DUKE POWER COMPANY									
MCGUIRE NUCLEAR STATION UNIT 2									
INSTRUMENT DETAILS									
STEAM GENERATOR FEEDWATER									
PRESSURE TEST POINTS									
3	Added stamp								
2	Added Installation List								
1	REV. CLASSIFICATION								
ORIG.	REV. CONTROL								
NO.	REVISIONS	CHKD	APPR	DATE	CIVIL	ELEC.	MECH.	INSPECTED	
								DESIGNED	DATE
								DRAWN	DATE
								CHECKED	DATE
								APPROVED	DATE
								DWG. NO.	MC-2499-CF13
								REV	3

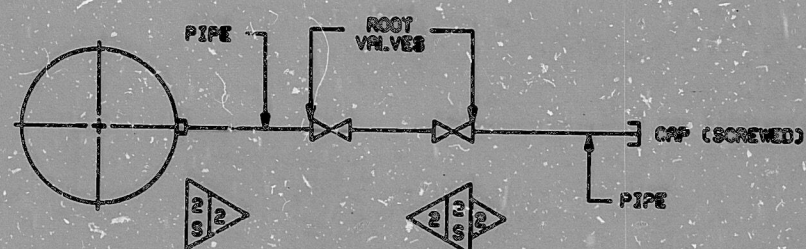
MARK NUMBER	DISTANCE TO FIRST ROOT VALVE	DISTANCE TO SECOND ROOT VALVE
2CFPX6380	5"	2 3/4" INCLUDES FULL COUPLING
2CFPX6390	5 1/4"	7 3/4" INCLUDES FULL COUPLING
2CFPX6400	3 1/2"	2 1/2"
2CFPX6410	5"	4"

Pipe stub after second root valve to be 6.0" with pipe cap.

These are maximum dimensions. If fewer elbows or couplings are used, the installation is also acceptable.
